CLIC Two-Beam Module Prototype in the LAB

Update of the TBM sequence from 1-0-0 to 0-0-1

Supporting/Pre-alignment system update

Configuration 0-0-1: Option 1

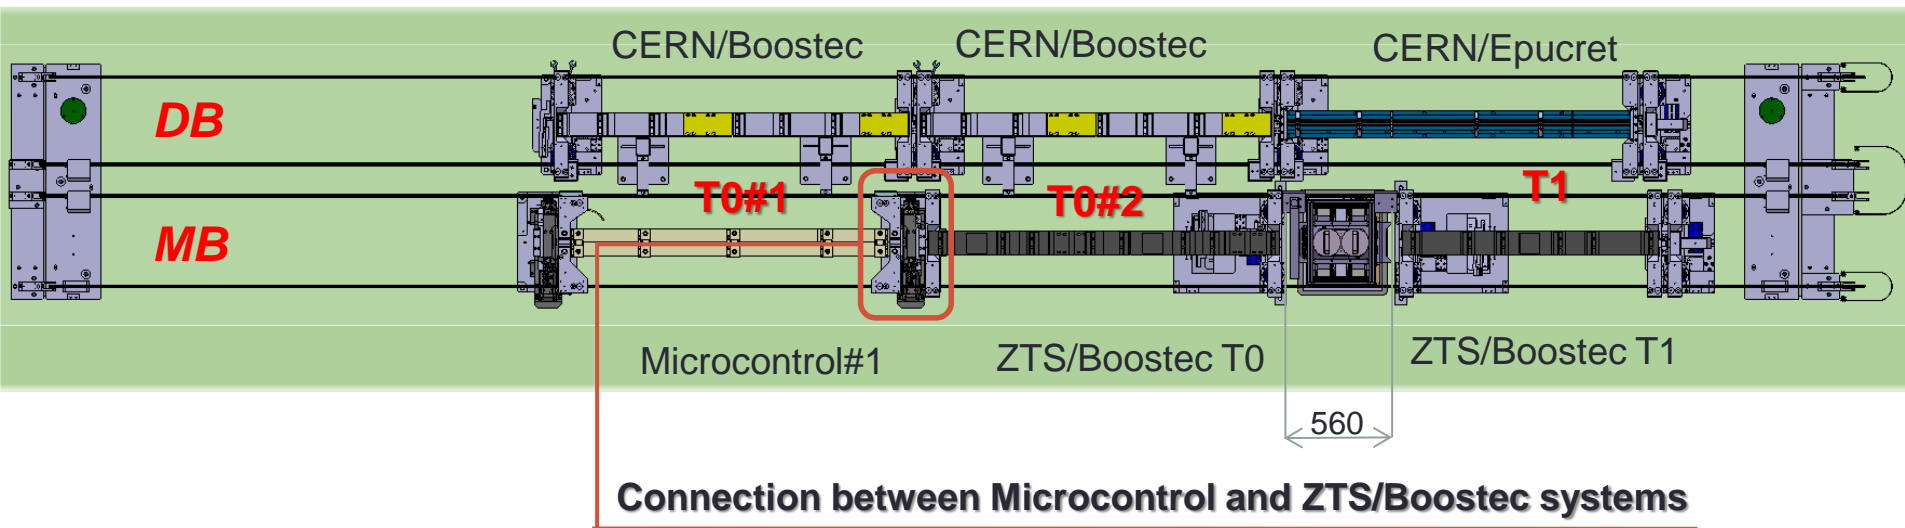
- Replace Microcontrol girder #2 by ZTS T0.
- Install MBQ and MB girder T1 (ZTS).

- It is not necessary to replace the existing TBM.
- The articulation point (Microcontrol-CERN) design should be performed.
- Shift between MB and DB for TBM T1.
- Possibility of installation 4xSAS mock-ups instead of 2m-long mock-up.

Configuration 0-0-1: Option 2a

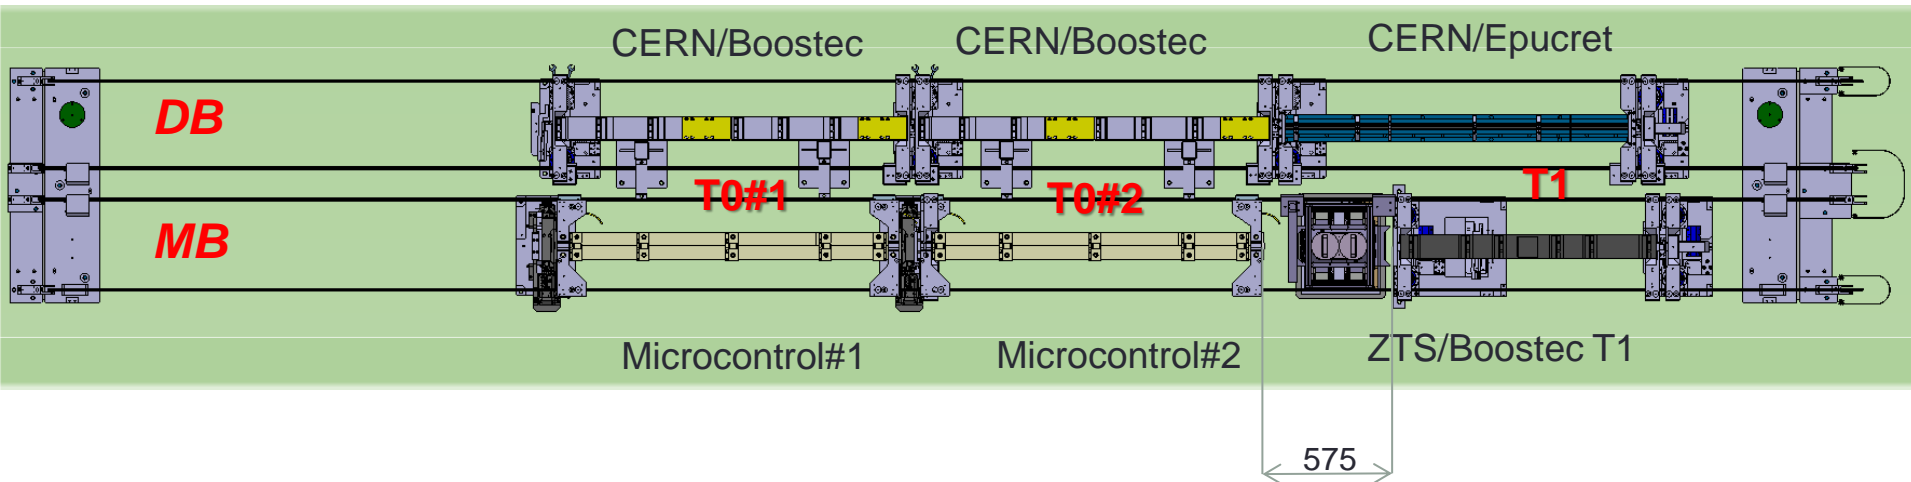
- Keep Microcontrol girder #2
- Install MBQ and MB girder T1 (ZTS)

- It is not necessary to replace the existing TBM.
- Special articulation point design is not needed.
- Shift between MB and DB for TBM T1.
- No possibility of installation 4xSAS mock-ups instead of 2m-long mock-up.

Configuration 0-0-1: Option 2b

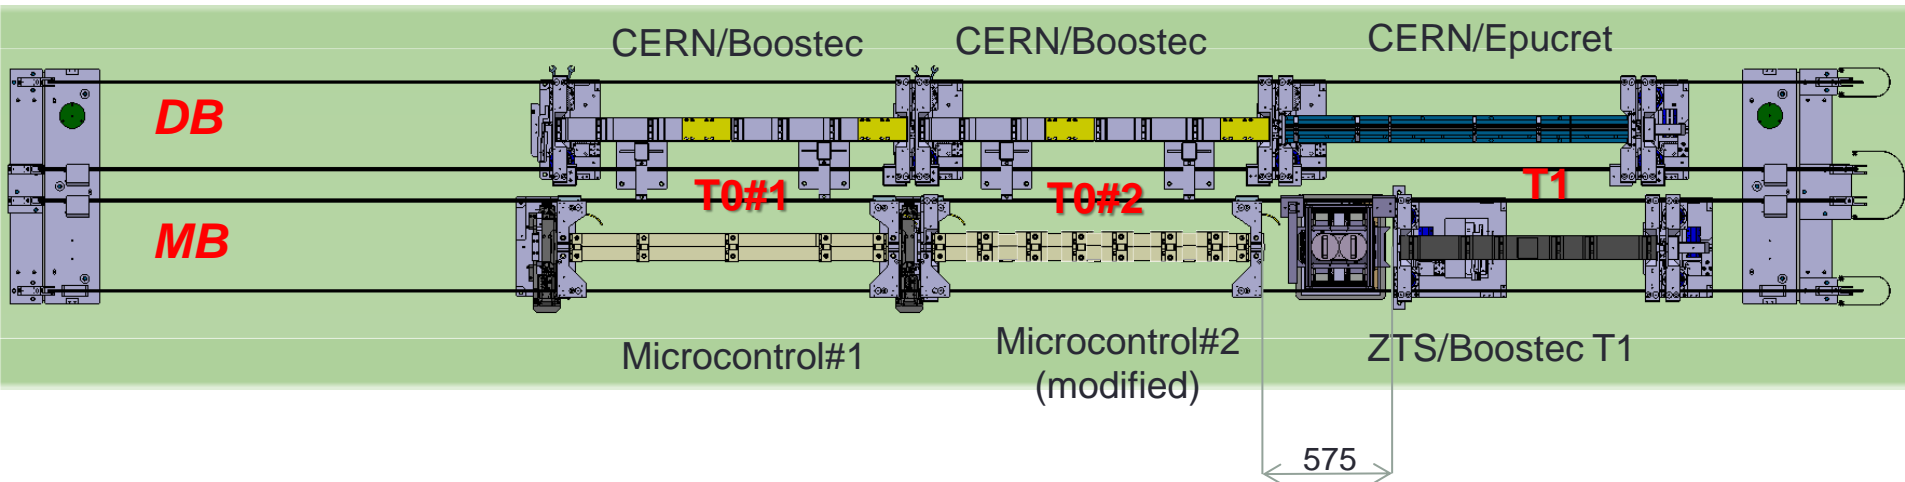
- Microcontrol girder #2 to be extracted and modified.
- Install MBQ and MB girder T1 (ZTS)

- It is not necessary to replace the existing TBM.
- Special articulation point design is not needed.
- Shift between MB and DB for TBM T1.
- Possibility of installation 4xSAS mock-ups instead of 2m-long mock-up.

Modification of the Microcontrol girder:

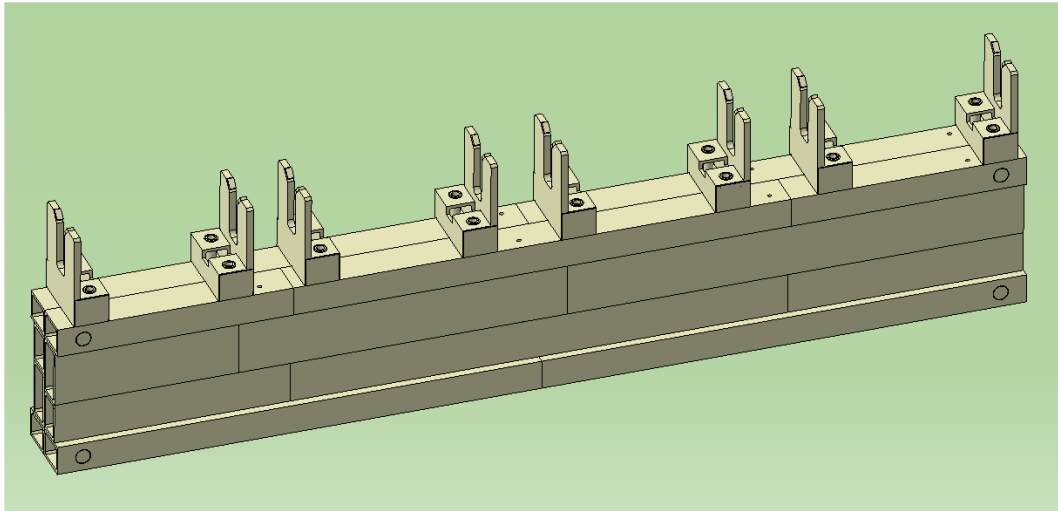
1. Replace existing V-supports, add 3 new V-supports:

2. Grinding of the girder to provide beam axis straightness

The possibility to be discussed with the supplier.
